MEMORANDUM

To: Kristine Sullivan
From: James M. Pretti, Jr., P.E., L.S., Member
Date: February 8, 2022
Re: The Enclave at Woodbridge
10 & 14 Merritt Avenue
Woodbridge, Connecticut

CE File No: 2022-400-01

National Flood Hazard Layer FIRMette

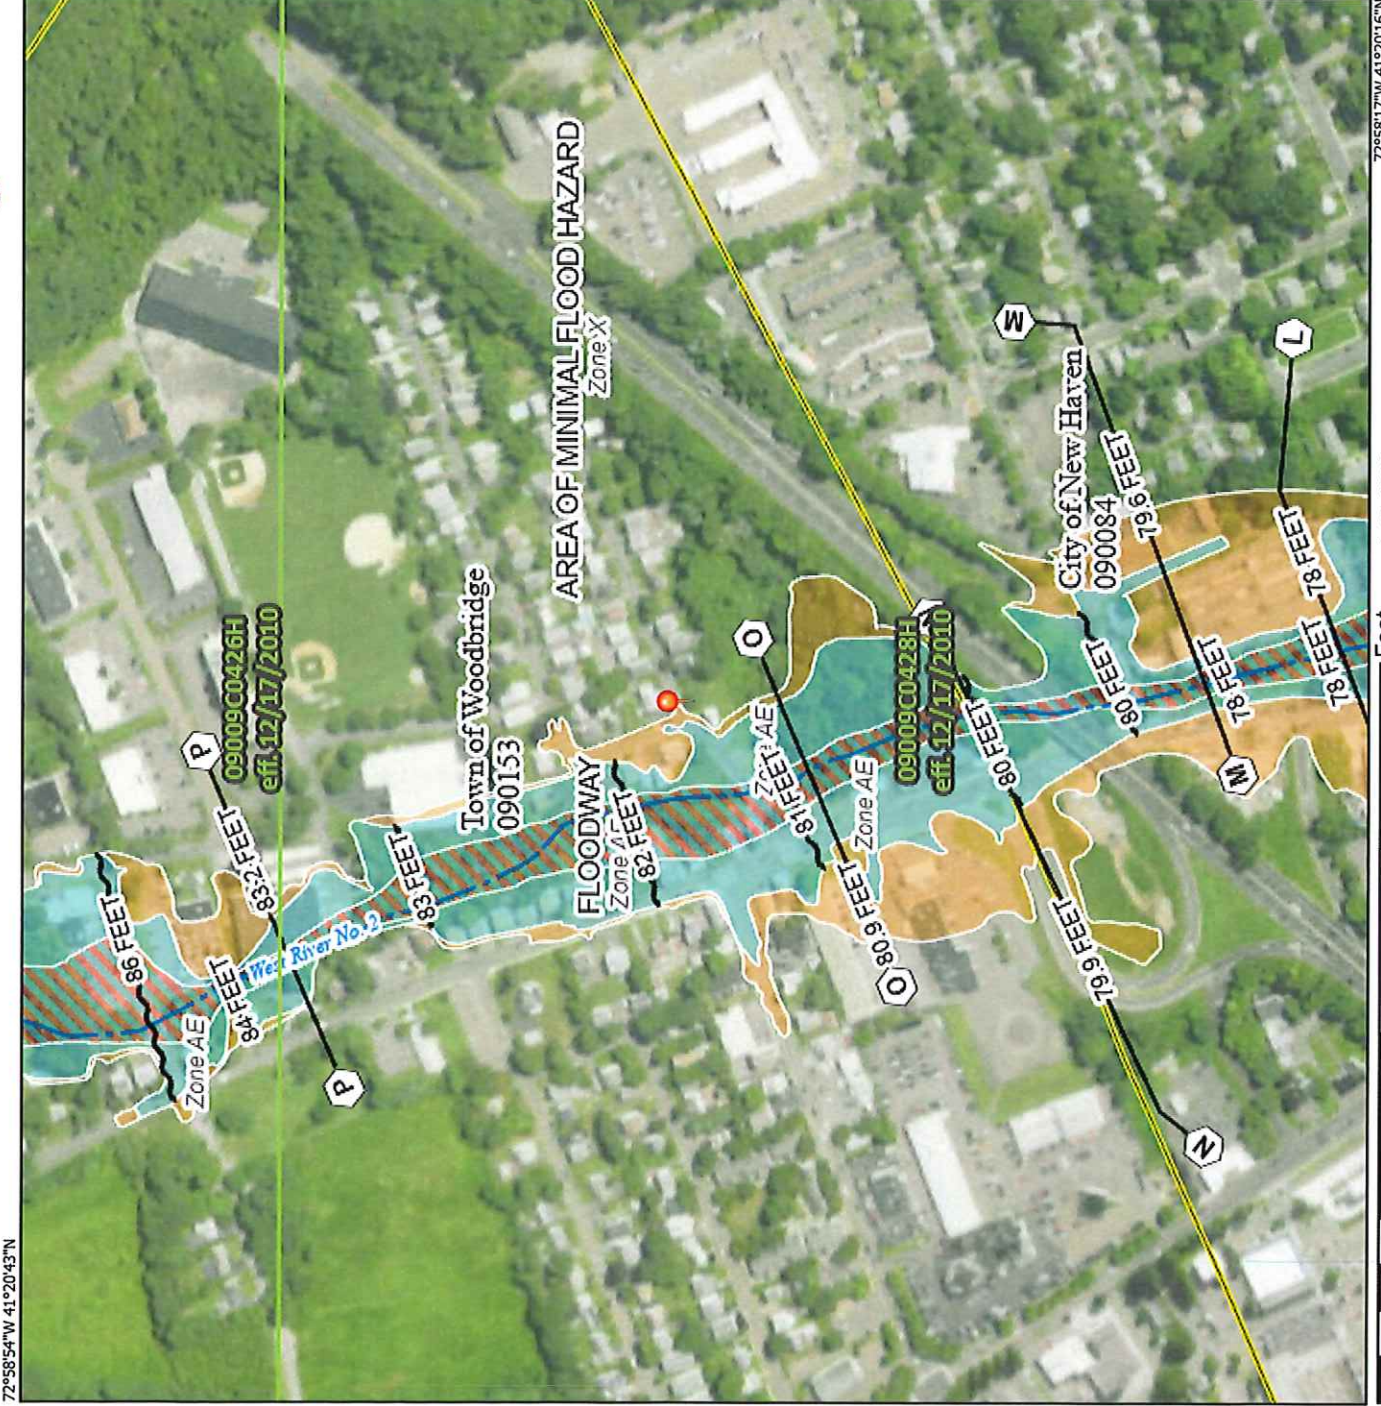
The parcel is partially within the AE special flood hazard zone per the current FEMA mapping (map no. 09009C0428H). The elevations of the cross sections at this location range from elev.=80 at the southern edge of the property to elev.=81 at the northern edge. The AE flood zone line depicted on the submitted plan set follows the elev.=81 contour, not the actual line depicted on the FEMA map. I believe unless one goes through the process of amending the mapping with FEMA, the lines on the map govern, not the actual elevation. I’ve attached a portion of the FEMA map.

Regardless, it appears that there is a significant amount of filling and structures proposed within this flood hazard area. Per Town of Woodbridge Zoning Regulations, Section 16: Provisions for Flood Hazard Reduction:

It does not appear that the compensatory storage volume has been addressed on these plans.
